**TO: Winnebago Industries, Inc. Dealers**

**SUBJECT: Campaign #104 – Auxiliary Start Solenoid Diode**

## INSTRUCTIONS TO PERFORM CAMPAIGN 104

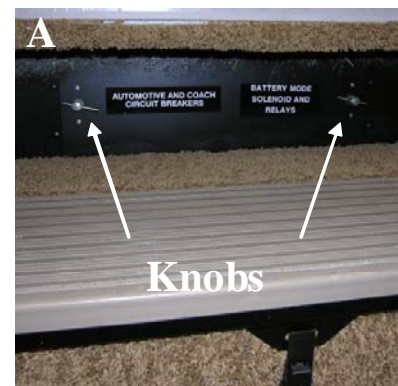
The procedure involves connecting a diode wire assembly from the center stud of the auxiliary start solenoid to the ground screw. This is to prevent the engine from shutting down if the battery boost switch is engaged with the engine running.
